PLANNING DEPARTMENT – Development Review Services

RE: **RFK Charter School - 4300 Blake Road SW**  
**Amended Grading and Drainage Plan**  
**Engineer's Stamp Date 10-6-2014 (File: N10D006)**

GRADING AND DRAINAGE REPORT

PROJECT NUMBER: 20-1007 MEC-10-041  
CAD FILE:   
DRAWN BY: JMJ  
CHECKED BY: VAM  
SHEET TITLE:   
SHEET NO.:   
SHEET TOTAL:   
GRADING AND DRAINAGE PLAN  
C-101R

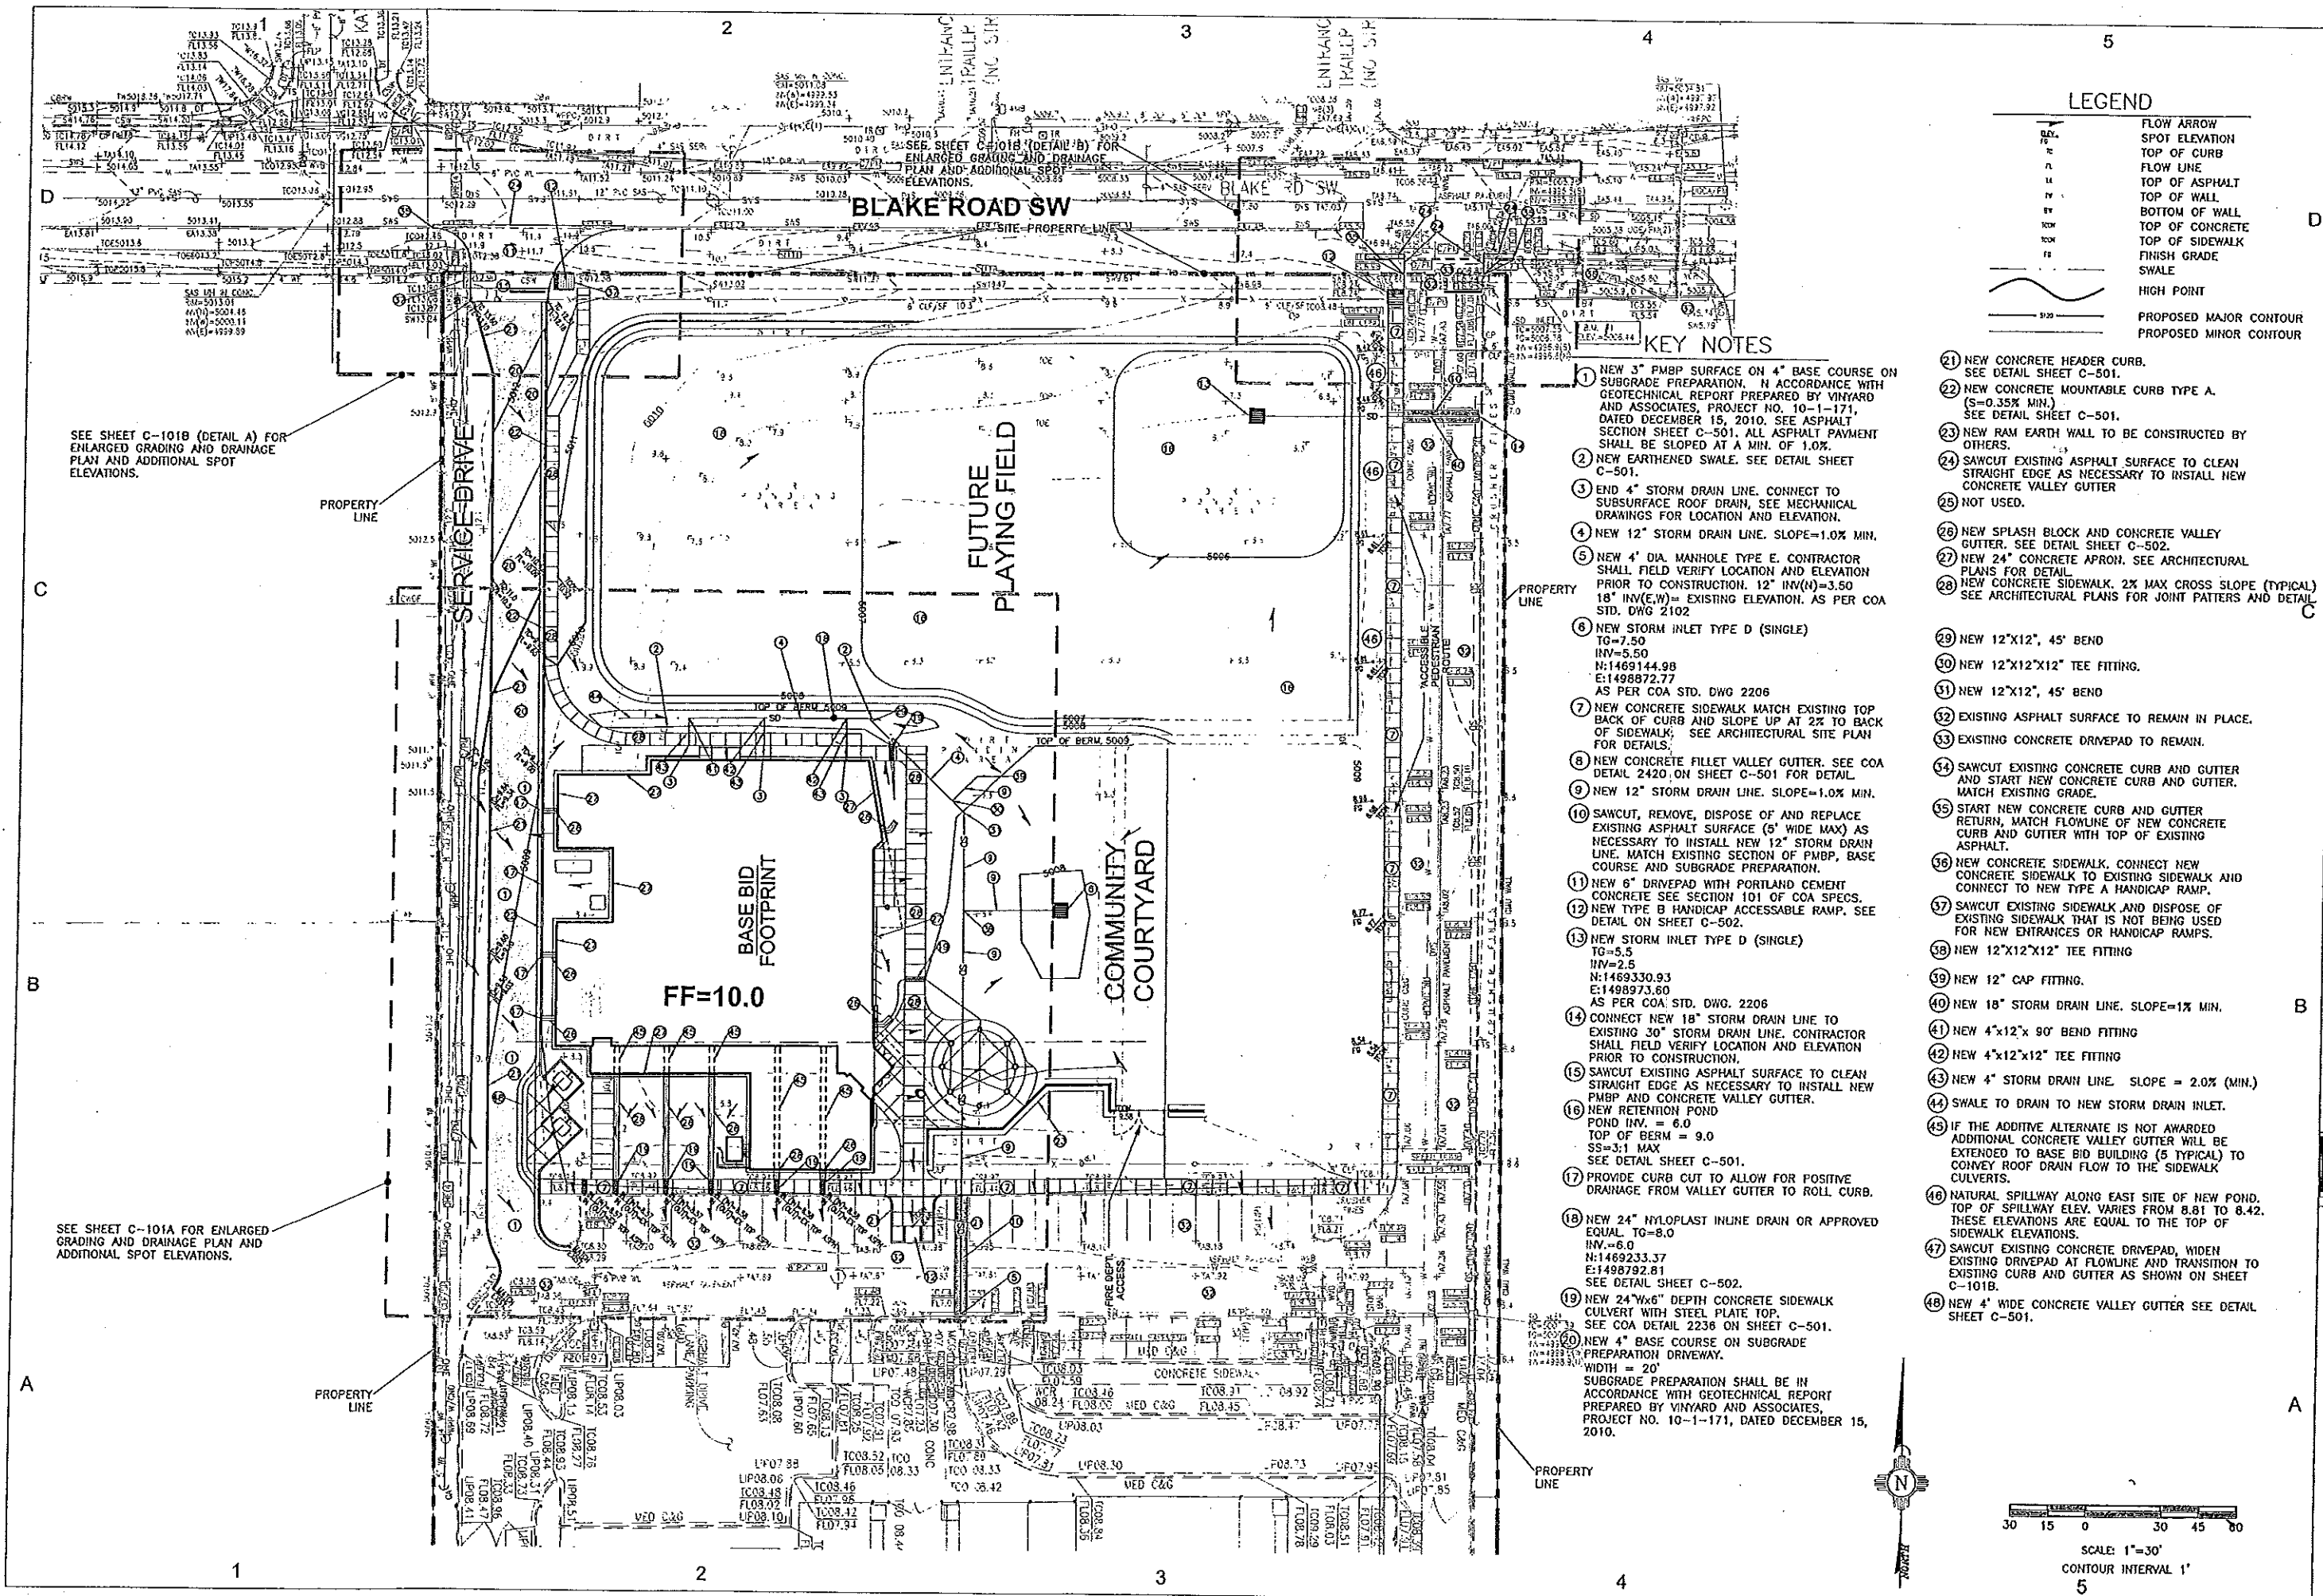
- The revisions from the previously approved plan appear to be the addition of trash enclosures and the addition of mountable curb and gutter along the east side of the service road. Drainage calculations were also revised.
- On the service road a line needs to be added to delineate where the base course ends and the PMBP surface begins.
